Model: Kir-C2 GW Expansion Unit (B658)	Date: 6-Jul-04	No.: MB658001
--	----------------	---------------

Modified Article: Parts Catalog Correction		Prepared by: M. Ishihara	
From: 1 st Tech. Support Sec. Service Support Dept.			
Reason for Modification:	<input checked="" type="checkbox"/> Parts catalog correction	<input type="checkbox"/> Vendor change	<input type="checkbox"/> To meet standards ()
	<input type="checkbox"/> To facilitate assembly	<input type="checkbox"/> To improve reliability	
	<input type="checkbox"/> Part standardization	<input type="checkbox"/> Other

Model: Kir-C2 GW Expansion Unit (B658)		Date: 20-Jul-04	No.: MB658002
Modified Article: Fax Cover		Prepared by: M. Ishihara	
From: 1 st Tech. Support Sec. Service Support Dept.			
Reason for Modification:	<input type="checkbox"/> Parts catalog correction <input type="checkbox"/> To facilitate assembly <input type="checkbox"/> Part standardization	<input type="checkbox"/> Vendor change <input checked="" type="checkbox"/> To improve reliability <input type="checkbox"/> Other	<input type="checkbox"/> To meet standards ()

Model: Kir-C2 GW Expansion Unit (B658)	Date: 22-Apr-05	No.: MB658003
--	-----------------	-------

Page 2 and 3

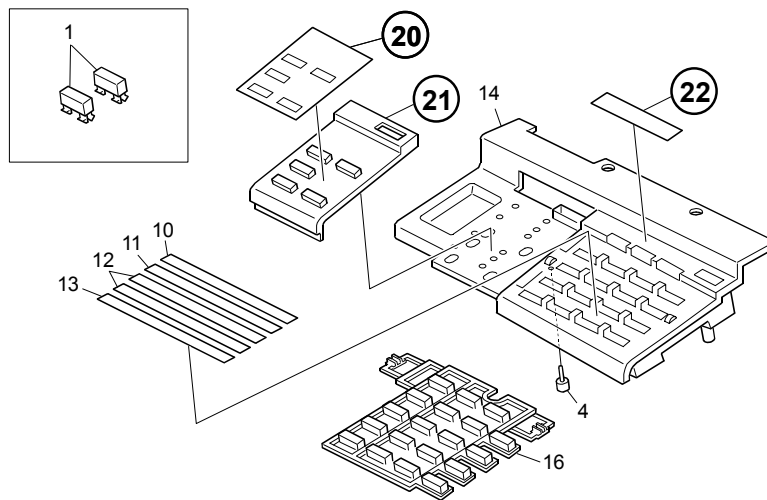
Please correct your Parts Catalogs as follows:

- Addition -

Part number	Description	Q'ty	Index	Note
B6201461	Fax Decal – NA ASIA	1	20	
B6201450	Fax Cover EU	1	21	
B6201421	Fax Cover NA	1	21	
B6581455	Expansion Sheet	1	22
